**Water distributor for Rotax 912 A and 912 UL****1) General:**

III.1

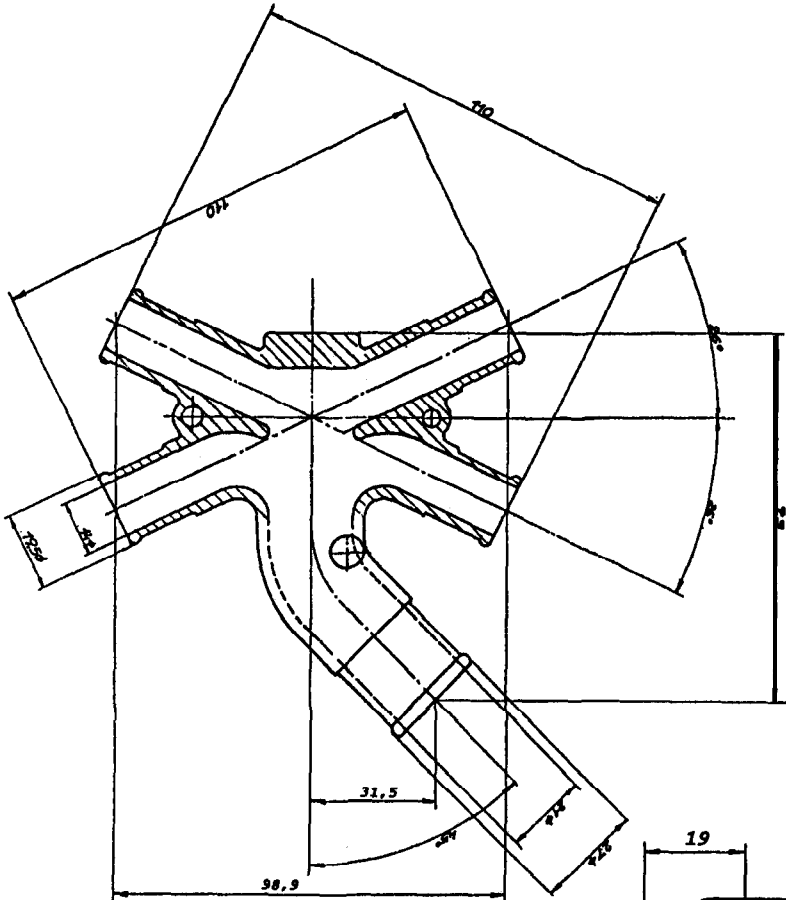
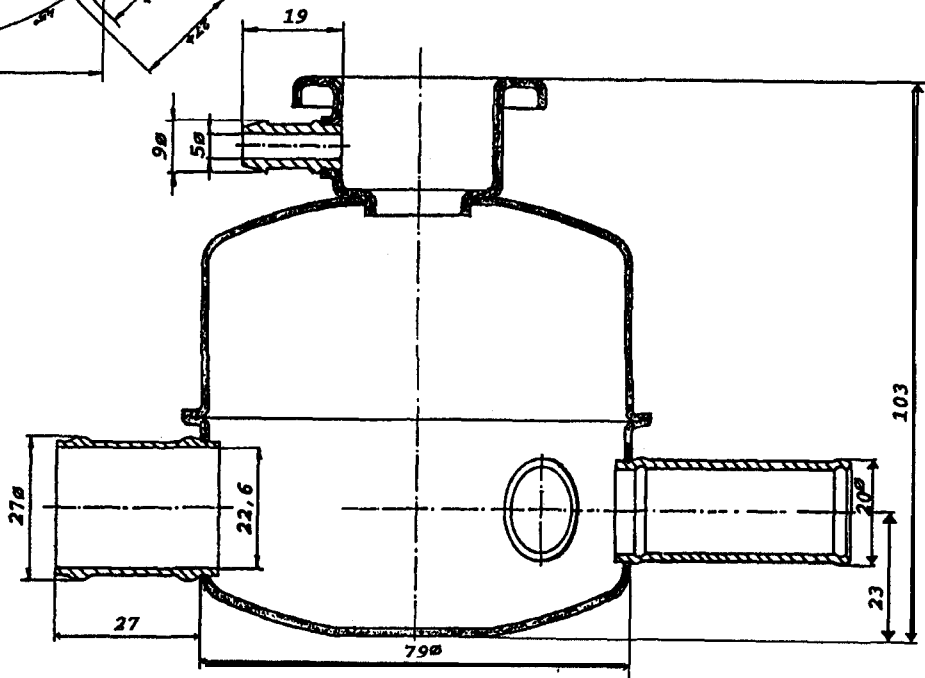
In view of technical development the water distributor, part no. 922 260 (**ill. 1**), has been replaced by an expansion tank with pressure and return valve cap, part no. 922 392 (**ill. 2**). Together with this expansion tank 2 coolant tubes, part no. 922 252, of other length must be used.

This expansion tank is available in two versions. The water outlet (**22,6 mm dia.**) can be positioned either 5 1° to the left or 5 1° to the right (part no. 922 397) looking from top. In serial production, part no. 922 392 (51° to the left) is installed.

The water distributor, part no. 922 260, used before is no longer available and is replaced by an expansion tank with 2 coolant hoses. This modification applies also for spare parts requirements.

For some engine installations this new expansion tank with coolant hoses cannot be used because of lack of space, or if the radiator is installed higher than the engine. In these cases there is the alternative to install instead of the expansion tank a water distributor, part no. 922 264 (**ill. 3**). The bottom part of this water distributor is identical with that of the new expansion tank, therefore the same installation of coolant tubes applies.

This water distributor has no pressure and return valve cap and can be installed, depending on installation requirements, with the convex part either upwards or downwards. However, a pressure and return valve cap has to be fitted,

- either on the radiator (if the radiator is installed higher than the water distributor),
- or on the expansion tank supplied standard with the engine (if radiator is installed lower than the engine and a closed radiator must be used).
